Access Compliance Report

Public Rights-of-Way

Intersection ID: 7381	Main Street: MAPLEGROVE_DR	Cross Street: N_HOSKINS_RD	Location: SE
ADA ID: 7F4B54EFB7FE	Ramp Type: Perp	Initial Pass/Fail: Fail	Overall Compliance: No
Severity Score: 36.25			
Codes/Mitigation Info/Possible Solution		Field Measurements/Component Compliance

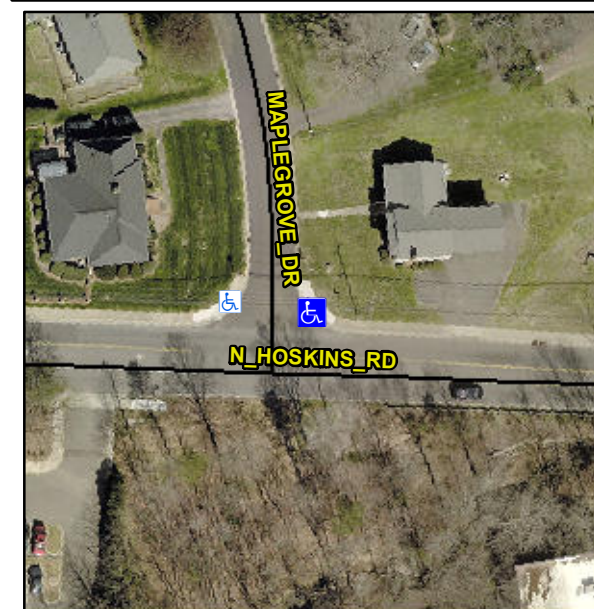
R304.5.1, R304.5.3

Compliance	Description	Data	Compliance	Description	Data
N/A	Ramp Length (in)	59.0	Yes	Ramp Slope (%)	8.2
No	Ramp Width (in)	31.5	No	Ramp XSlope (%)	2.8
N/A	Flare Type LT	N/A	N/A	Flare Type RT	N/A
N/A	Flare Slope LT (%)	N/A	N/A	Flare Slope RT (%)	N/A
N/A	Flare Traversable LT?	N/A	N/A	Flare Traversable RT?	N/A
N/A	Landing Length (in)	N/A	N/A	DWS Provided?	N/A
N/A	Landing Width (in)	N/A	N/A	DWS Contrast?	N/A
N/A	Landing Slope (%)	N/A	N/A	DWS Length (in)	N/A
N/A	Landing X Slope (%)	N/A	N/A	DWS Full Width?	N/A
N/A	Landing Curb? (Y/N)	N/A	N/A	DWS Offset (in)	N/A
N/A	Shared Landing?	N/A			
N/A	Gutter Ponding?	N/A	N/A	Gutter Slope (%)	N/A
N/A	Gutter Lip Ht (in)	N/A	N/A	Gutter X Slope (%)	N/A
N/A	Painted X Walk1?	No	N/A	Painted X Walk2?	N/A
	X Walk 1 Direction	To NW		X Walk 2 Direction	N/A
N/A	X Walk 1 Width (in)	N/A	N/A	X Walk 2 Width (in)	N/A
	X Walk 1 Slope (%)	6.1		X Walk 2 Slope (%)	N/A
	X Walk 1 X Slope (%)	3.2		X Walk 2 X Slope (%)	N/A

Remove & Replace Entire Ramp.
